**HINCKLEY NATIONAL
RAIL FREIGHT INTERCHANGE**

**Sapcote Technical Note [Appendix 2 (B) -
Additional Information Provided to Auditor
and Auditor Response]**

Stage 1 Road Safety Audit
RESPONSE REPORT (SAPCOTE ONLY)

24-1363.09-RSA1 – B4669 Leicester Road, Sapcote

ILLUSTRATIVE PLAN OF SHARED AREA OUTSIDE SAPCOTE CO-OP

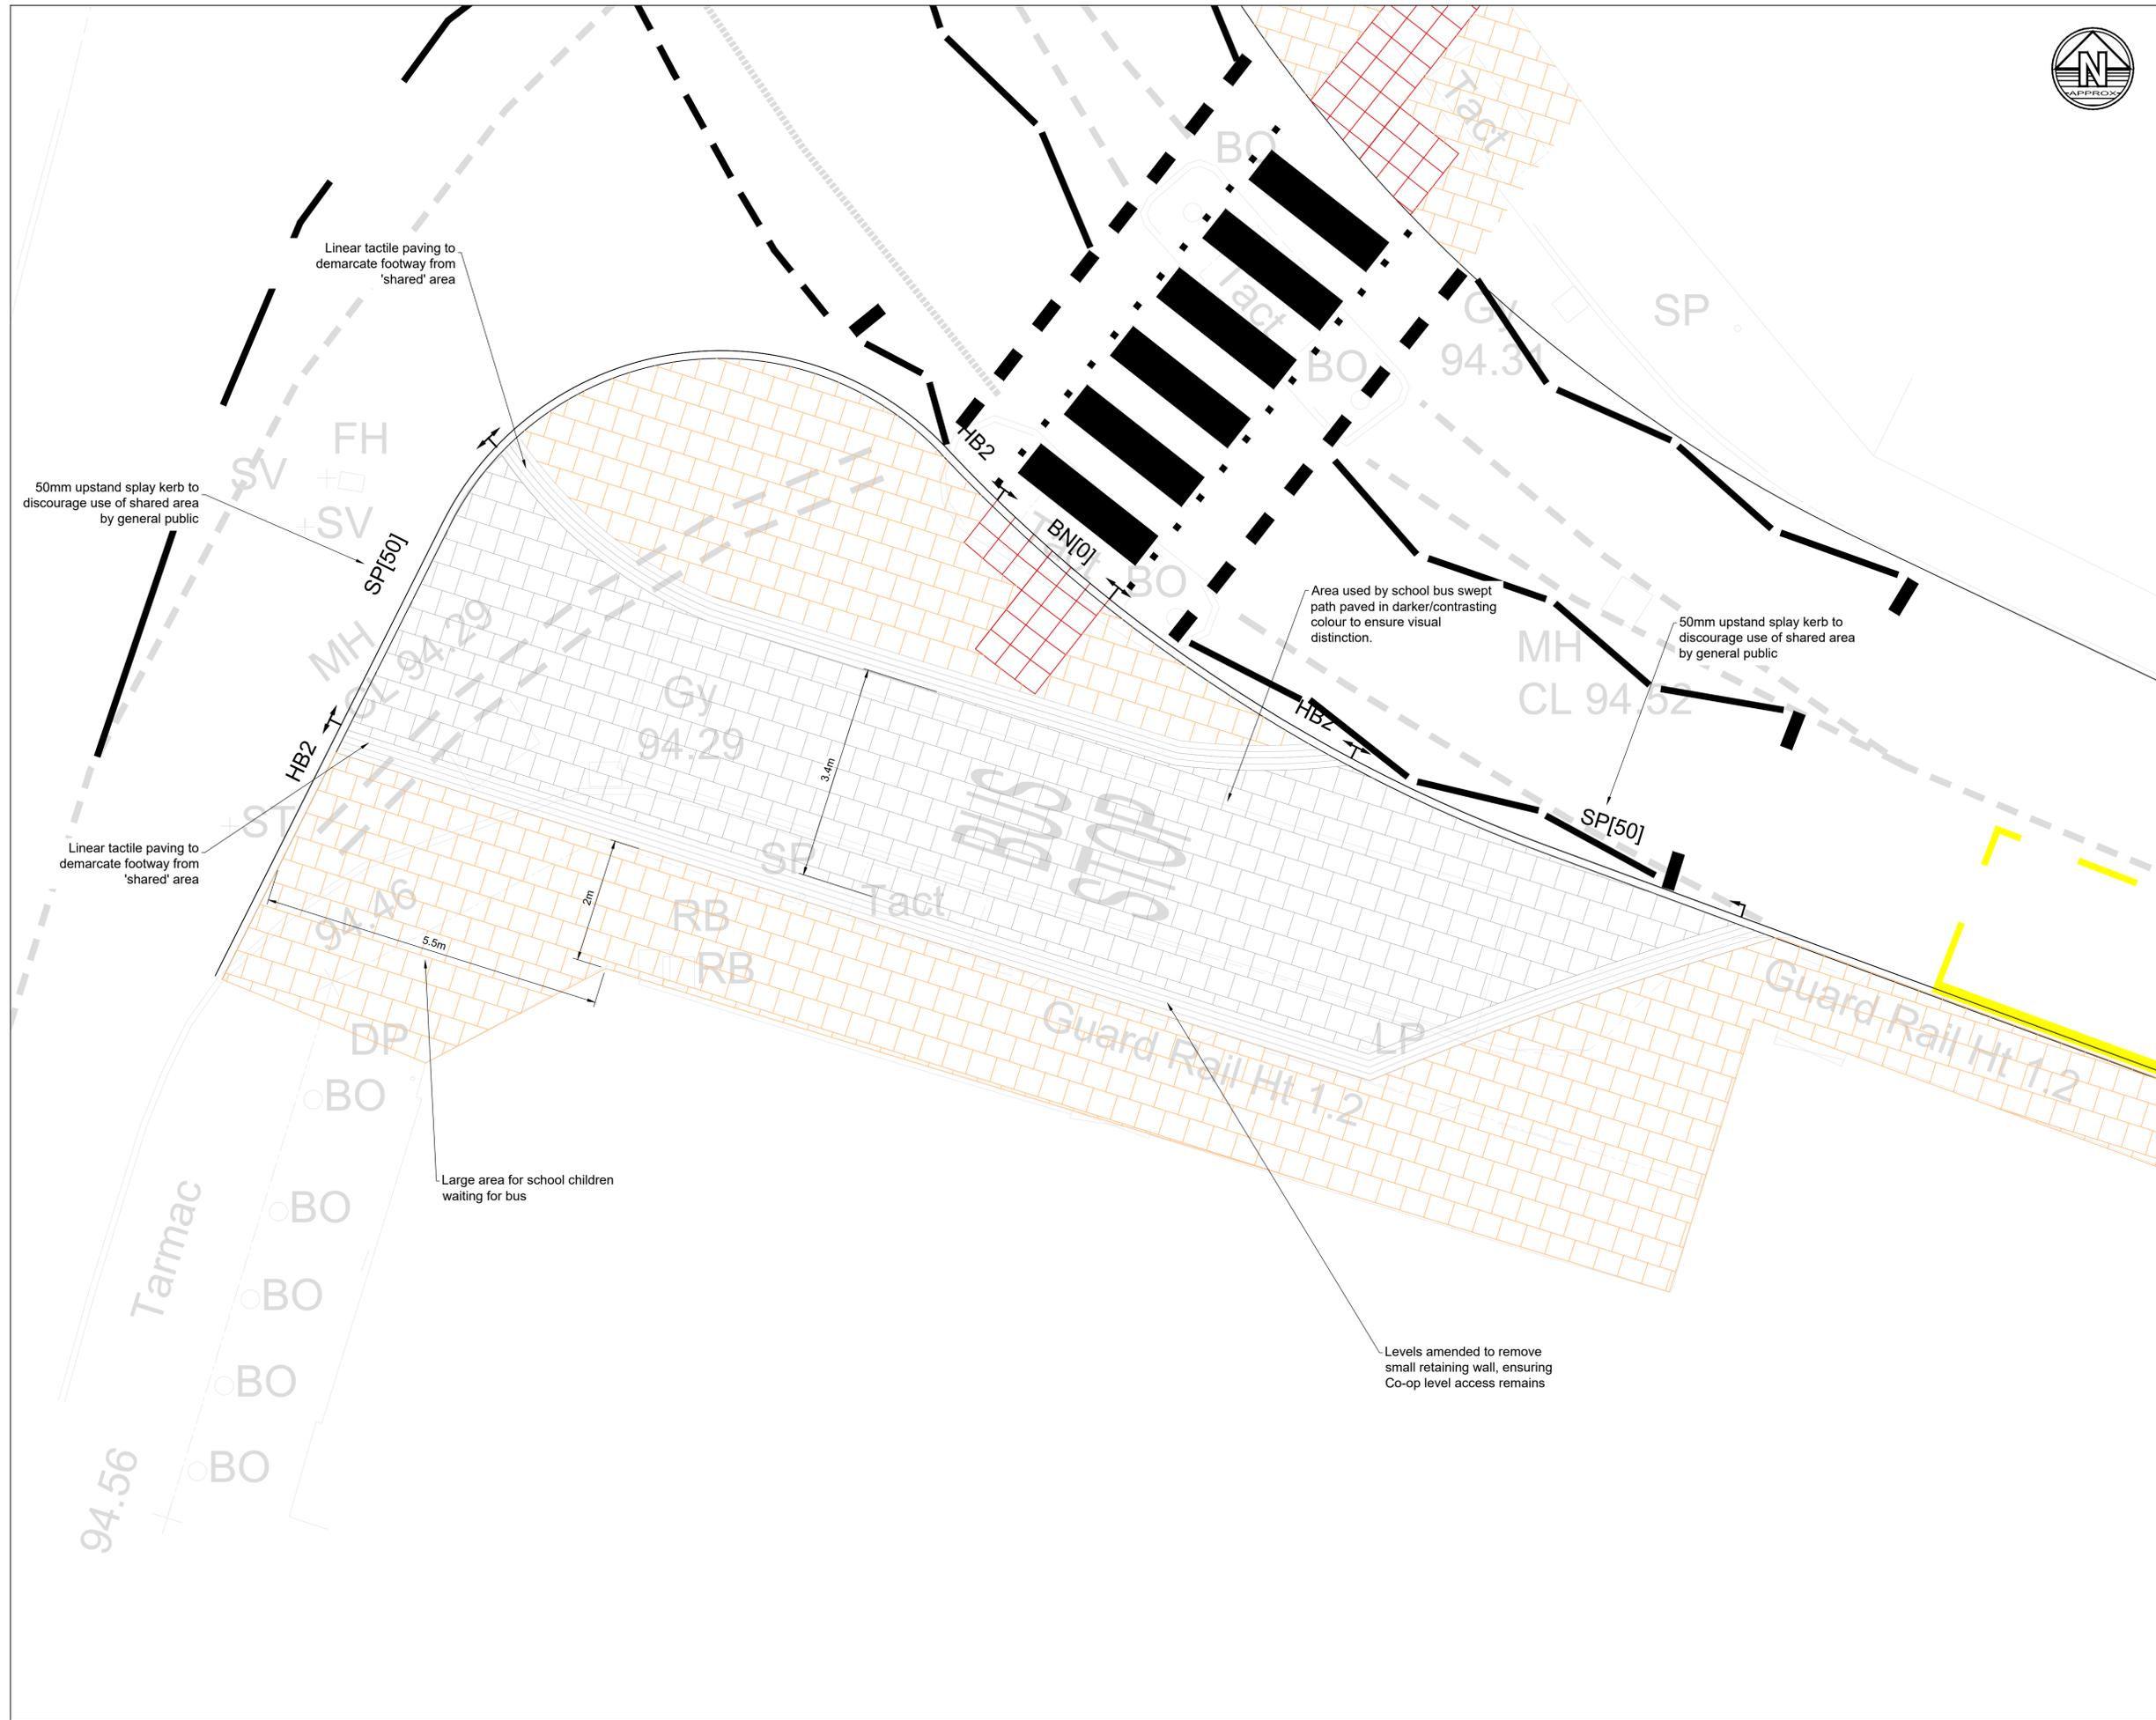
RSA Ref.	RSA Problem and Recommendation	Design organisation response	Auditor Response	Agreed RSA action
	<p>Location: Leicester Road - proposed bus stop / loading bay within "shared space" footway. Summary: School bus movements within the footway risk vehicle to pedestrian collisions.</p> <p>Under the existing layout school buses and delivery vehicles are able to pull into the lay-by in front of the Co-op. Whilst the intention is to maintain this existing situation, the changes to the layout here mean that the current lay-by will effectively become (and resemble) footway. This change is likely to result in pedestrians, specifically school children, waiting over a wider area as opposed to being concentrated within the footway when waiting for and alighting from the school bus. There is a concern that this will increase the risk of vehicle to pedestrian collisions, particularly given the complex manoeuvre required to fully enter the bay.</p> <p>Recommendation: It is recommended that an alternative route / provision is created for the school bus stop/loading bay which may require a wider and more considered approach and not one that simply attempts to mirror existing circumstances.</p>	<p>Agree with RSA recommendation: In Part</p> <p>The designer agrees that careful consideration is required regarding the demarcation of any shared surface in this area with suitable tactile and contrasting coloured paving to clearly identify the areas for vehicle use.</p> <p>The Co-op have a service area in their car park on Church Street but the designer were advised by the overseeing organisation that this area is currently used by vehicles servicing the Co-op. It should be noted that it is contrary to traffic regulations for service vehicles to use the existing bus stop, however provision was made in the proposed design, utilising shared surfacing for the delivery vehicle to use this areas in the event that the overseeing organisation elects to amend the relevant traffic regulations.</p> <p>While the majority of passing bus services will use the on carriageway stop (provided on the B4669 as part of the HNRFI works), the overseeing organisation also advised that school bus services currently stop in this area. The swept path movement for buses using the area will be the same as it is currently as the area available is the same. It is the designer's view that the careful use of tactile paving, small kerb upstands and contrasting paving in this location can enable the area to be utilised successfully as a shared surface and to allow buses and school children to wait safely without coming into conflict with each other.</p>	<p>The Audit Team have reviewed the amended design incorporating tactile paving, the use of a darker material within the area used by vehicles and a 50mm splay kerb to the access / egress for the area as shown in drawing HRF-BWB-HGN-HW18-DR-CH-101 rev P01.</p> <p>It is felt that this approach largely mitigates the concerns raised in the RSA1 and will likely deter some of the existing improper use of the space by the general public.</p> <p>It is recommended that appropriate signing to highlight the restricted use of the space is incorporated into the detailed design.</p>
